## NuLu Review Overlay District

### Overlay District Permit Report of the Committee

**Case No:** 19COA1067  
**Classification:** Non- Expedited

**Property Address:** 820-828 E. Main Street

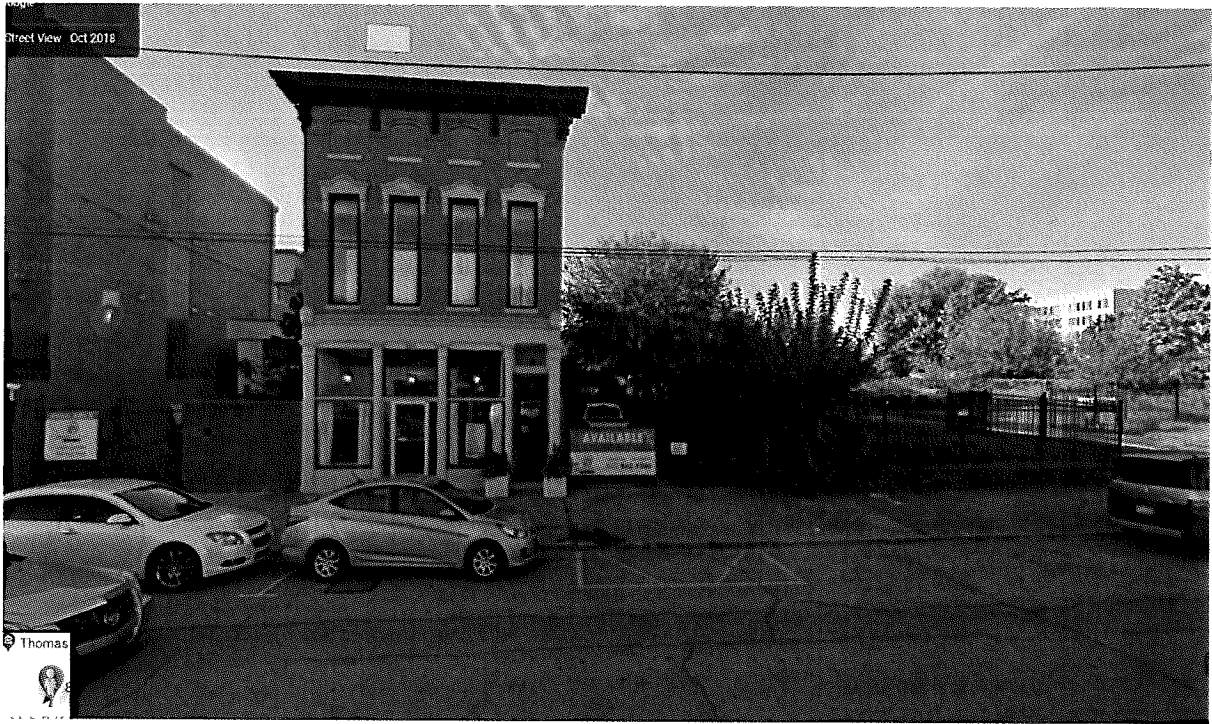
After the Staff presentation, Applicant and Architect Jeff Rawlins presented a revised design and renderings to the Committee. The revised design documents were on a personal computer and therefore hard copies were unable to be submitted into record during the proceedings (the applicant submitted those renderings to staff by email on April 30, 2019). The revised design eliminated the proposed building at 820 E. Main Street and expanded the proposed surface parking lot. Mr. Rawlins explained that the construction of a building at 820 E. Main was not feasible due to

financial concerns at this time. While the property owner may construct the building later, it is no longer planned and should not be reflected in this review. Chair Tatman expressed concern over the lack of a building presence at this location. Ms. Tatman asked the Committee to consider the impact of a surface parking lot to this area of NuLu. Ms. Tatman suggested the applicant present a design with a building façade facing E. Market Street in front of the surface parking. Other committee members agreed on the need to screen the parking area from the public way. Mr. Marzian agreed with Ms. Tatman and was complementary of the general project concept. Mr. Marzian made a motion to approve the Staff Report as written and to accept the plans as presented with the addition of Conditions #3 and #4. Mr. Crumie seconded the motion. The motion passed unanimously.

1. Signage shall comply with Design Guidelines and be submitted for review and approval prior to installation.
2. Final building design and materials selection to be submitted to Staff for review and approval.
3. For better compliance with Guideline B7 the applicant shall try to raise the height of the building at 828 East Main Street or otherwise revise the design and submit to Staff for review and approval.
4. The new parking lot at 820 E. Main Street shall be screened in compliance with Guideline SP4. The design shall be submitted to Staff for review and approval.
